# Bureau of Environmental Health

## ONSITE SEWAGE DISPOSAL SYSTEM

PROPERTY ADDRESS: 1751 Underwood Road

SUBDIVISION: Streaker Property

**FIRST FLOOR PLAN**

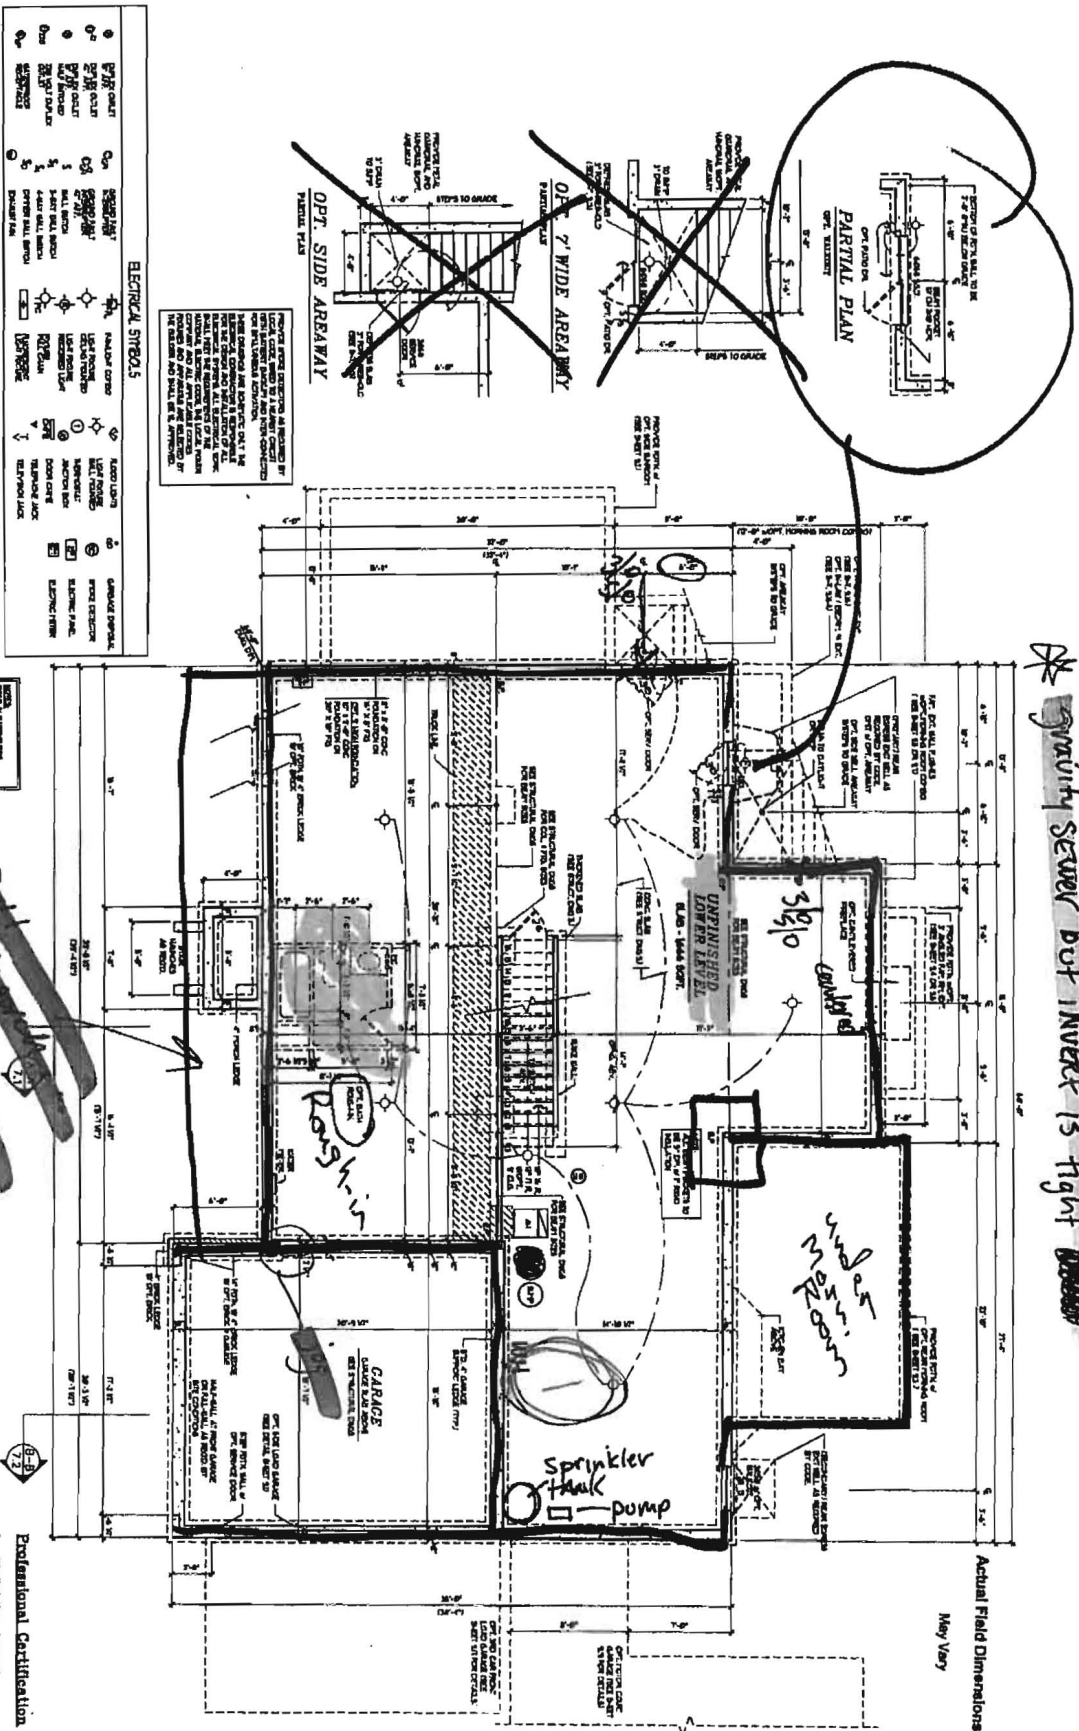
Due to the ruff in located in the basement county and state code considers this a potential for a fifth bedroom if the basement is finished. Your building permit states 4 and it must be changed to five. Your septic plans must be changed to five also.

\* Gravity sewer but invert is tight around

PLAN

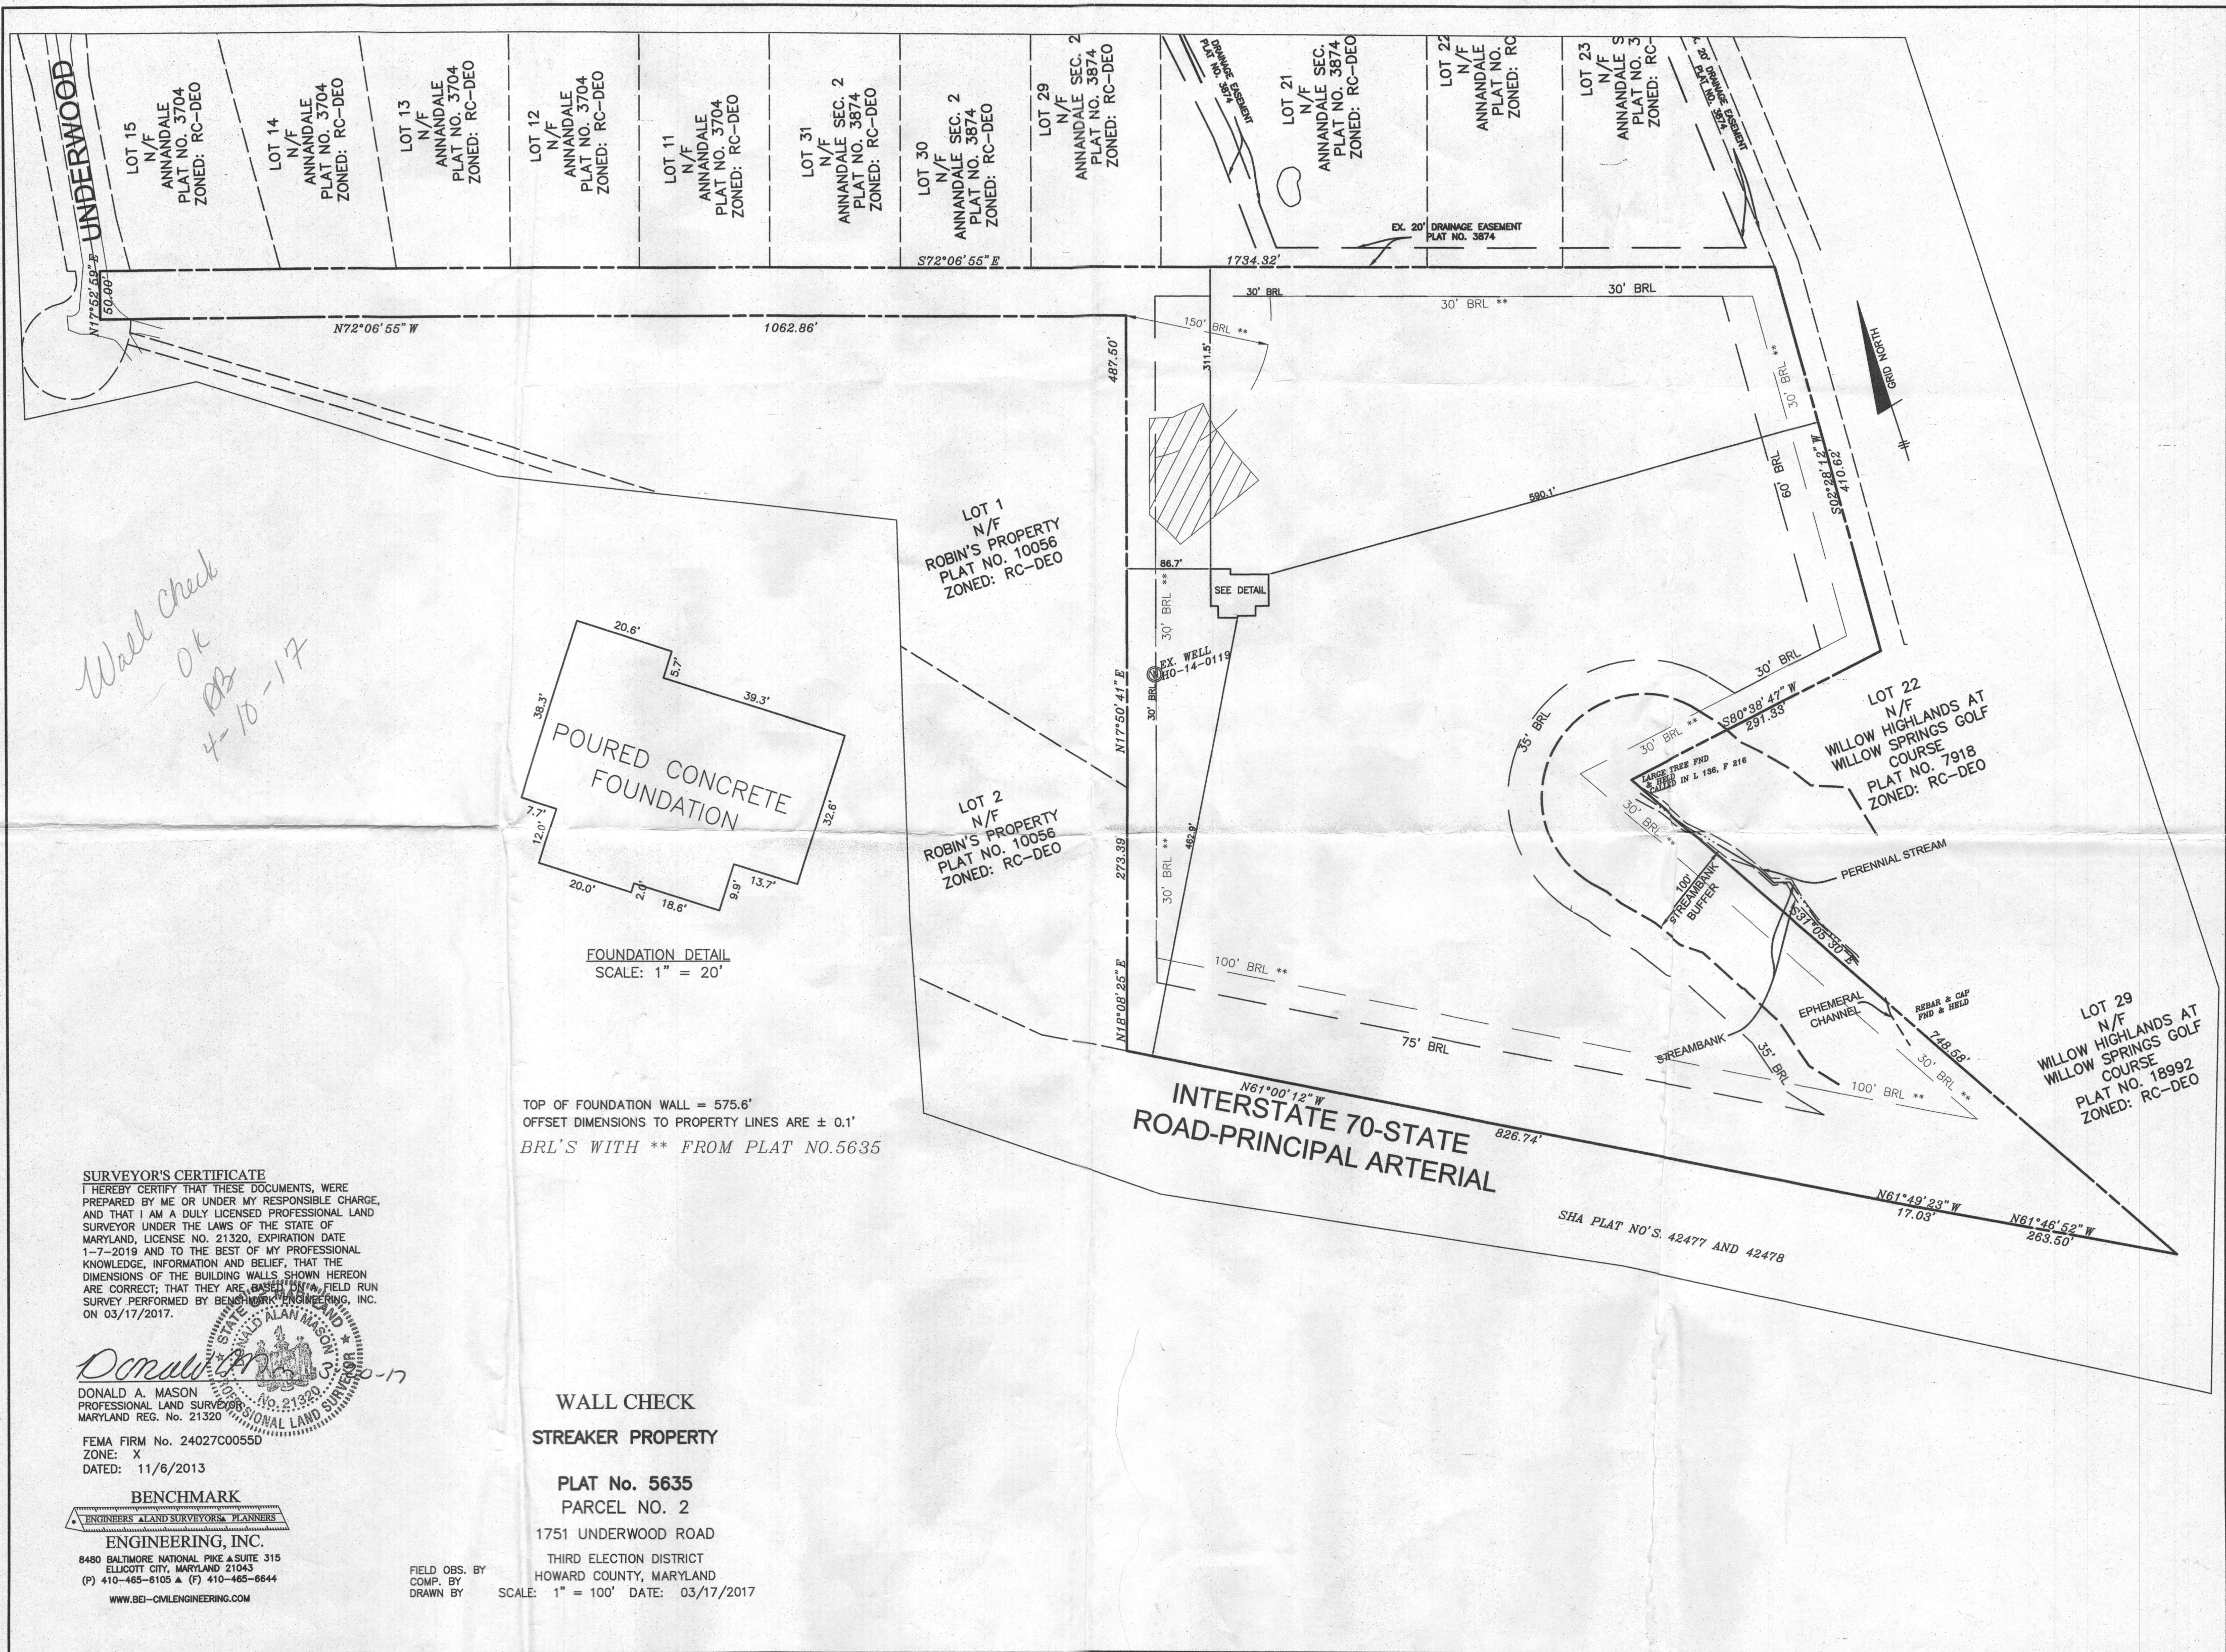
\* 115UF @ 1.5%  
FROM HOUSE TO  
TANK.

PLAN  
 SCALE: 1" = 50'

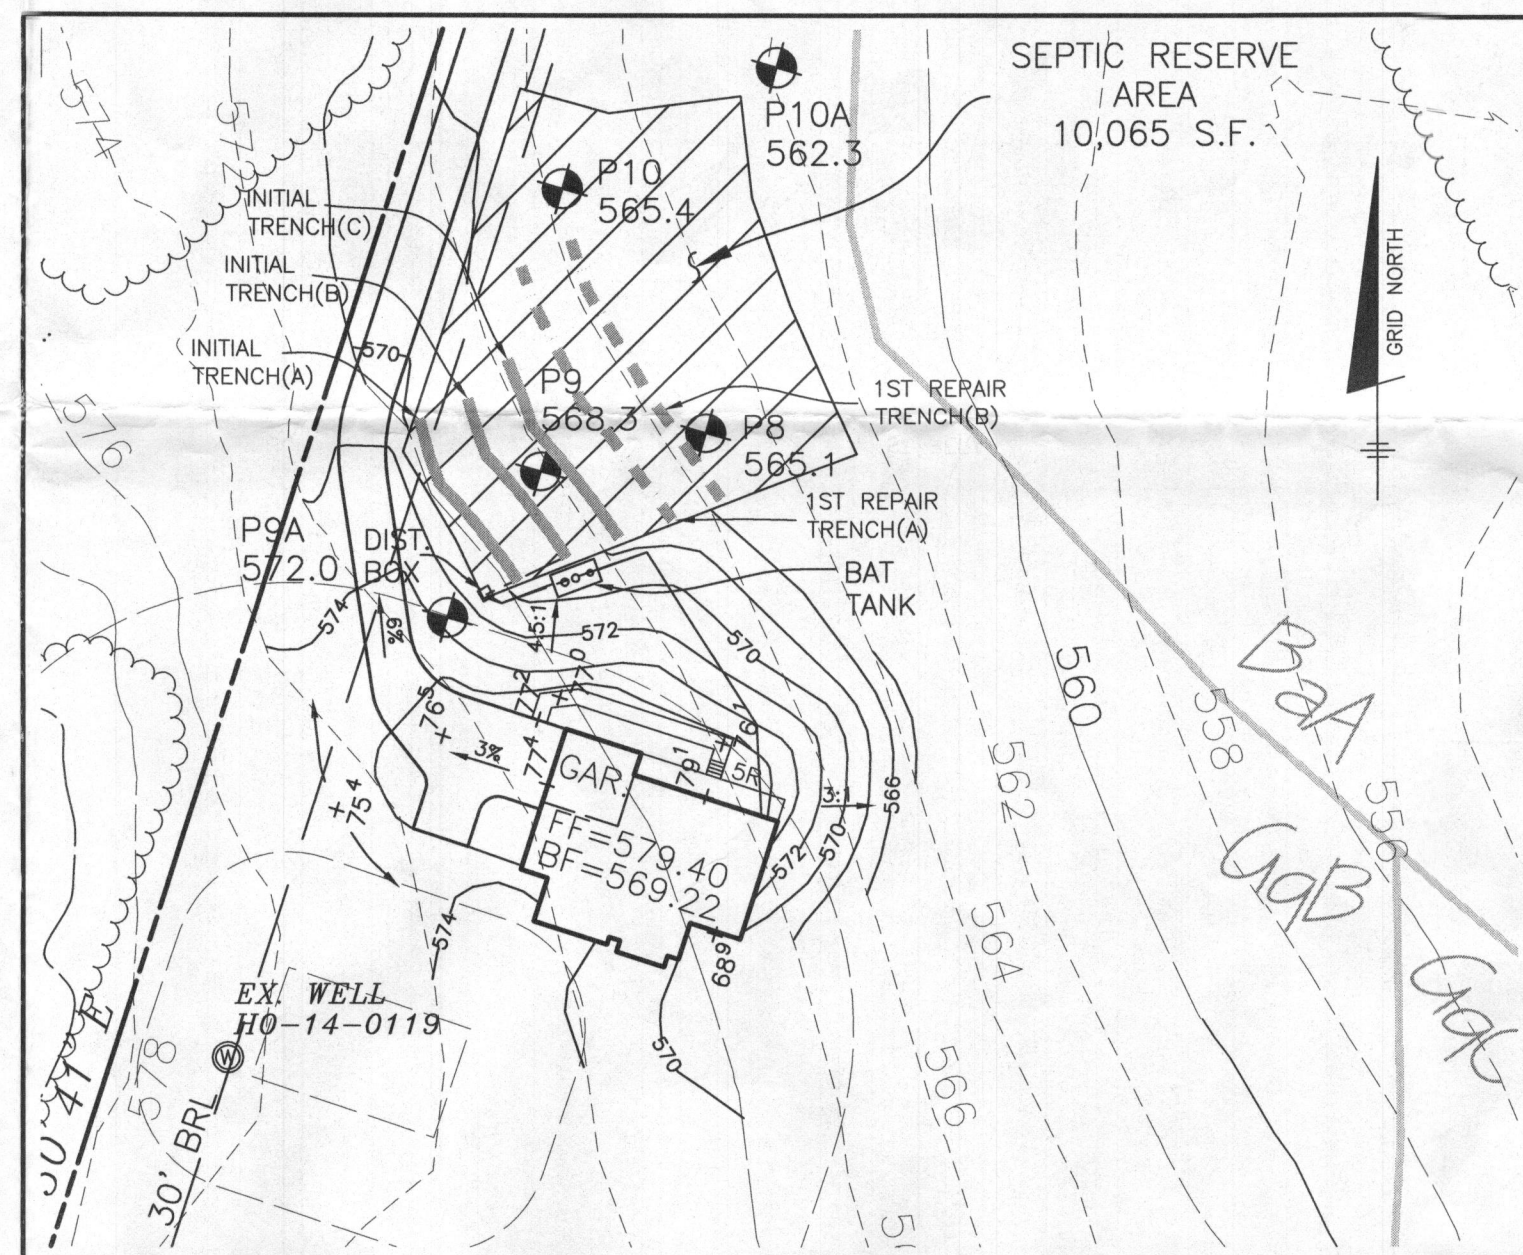
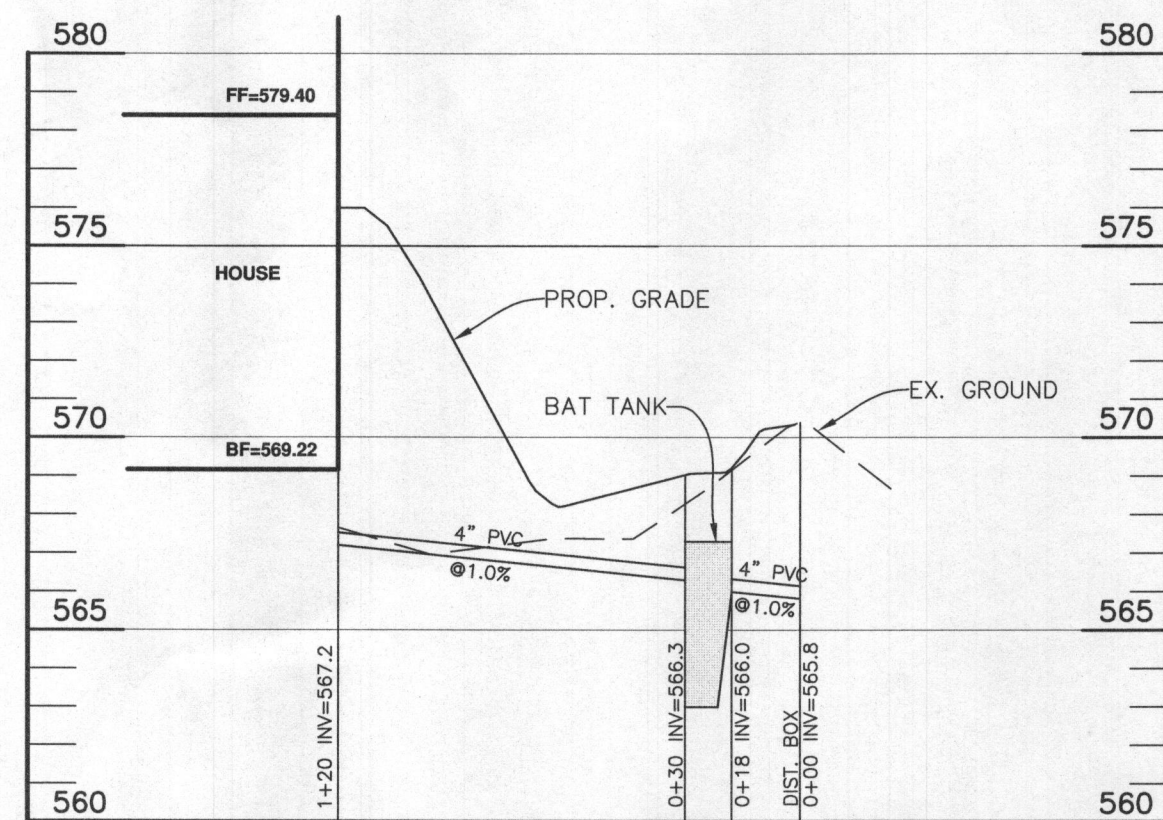
I reviewed the plan. I didn't see a set of specs for the property in the file. I'm wondering if you got any from Dana? From my look at the perc test results, the specs should be a 0.8 loading rate with sidewall credit from 3-8' (see

attached spec sheet for all three systems). This gets you a total trench length only a few feet longer than what you have, but you'd have to switch to a pumped system to get an invert at 3'. If you kept it at 4' and gave up a foot of sidewall, you'd need another trench to get the total length needed. Also, you don't need to show specs for system #3 if it's obvious that a 3<sup>rd</sup> system can fit, such as with this case. If it's a tight squeeze, we look to see the 3<sup>rd</sup> system.

Also, if you end up keeping it as a gravity system, please note that it is very possible that conditions in the field will require it to change to a pumped system, which will necessitate a revised BAT plan. At 1% fall all the way down the line, any small change in elevation of the line leaving the foundation or a change in ground elevation conditions could prevent fall from being achieved.

Your plan looks fine. However, the grading near the driveway and in the back of the house must remain 25 feet from the septic area including the tank. And the distribution box is normally at the end of the trench or closer to it. Please revise and resubmit.

I revised the grading within 25' of the septic to a slope of 4.5:1 or 22%. I also move the trenches up so that they were closer to the distribution box. Let me know if this works for you and I'll send up the plan for approval. Any questions let me know.
